MIL-A-19521A(SHIPS)
 AMENDMENT - 3
 15 AUGUST 1967
 SUPERSEDING 1/
 Amendment - 2
 26 February 1963

ANODES, CORROSION PREVENTIVE, ZINC, AND PLUGS, ZINC ANODE RETAINING:
 DESIGN OF AND INSTALLATION IN SHIPBOARD CONDENSERS AND HEAT EXCHANGERS

This amendment forms a part of Military Specification MIL-A-19521A(SHIPS), dated 30 January 1961.

Figure 3 - Class A, type I support plug for 2RN anode.

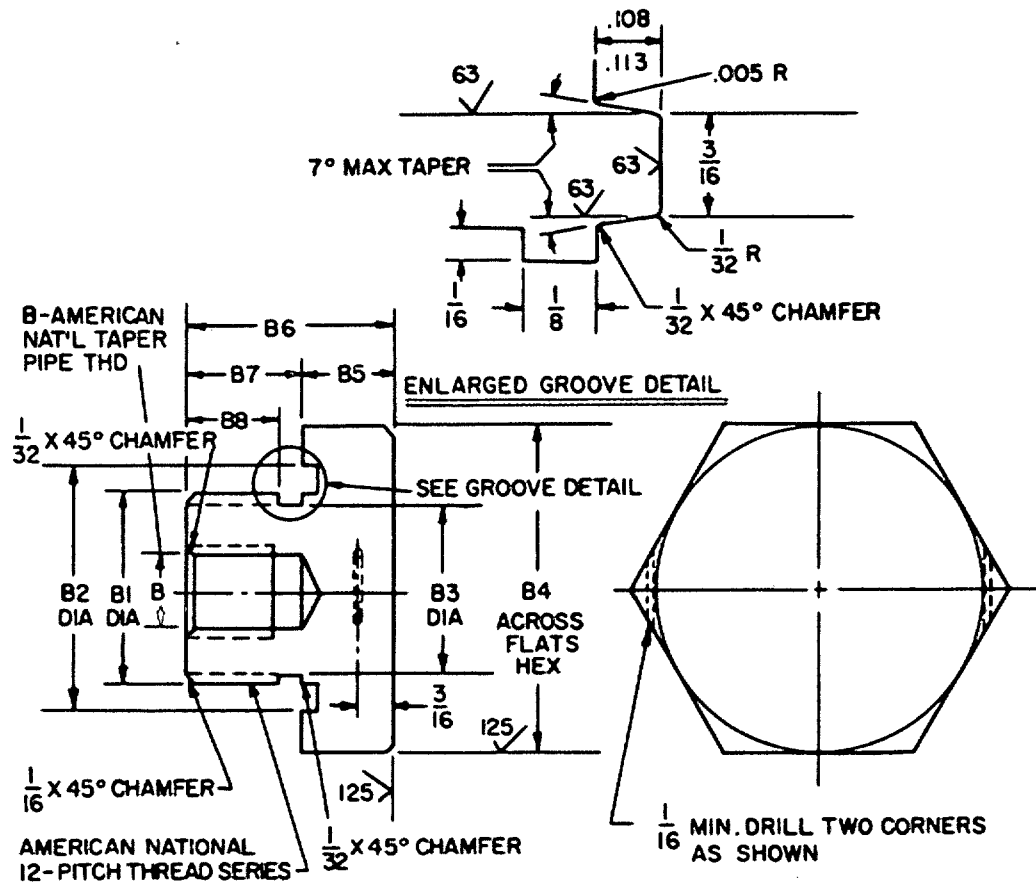
Pages 5 and 6, figures 3 and 4: Delete and substitute the attached figures.
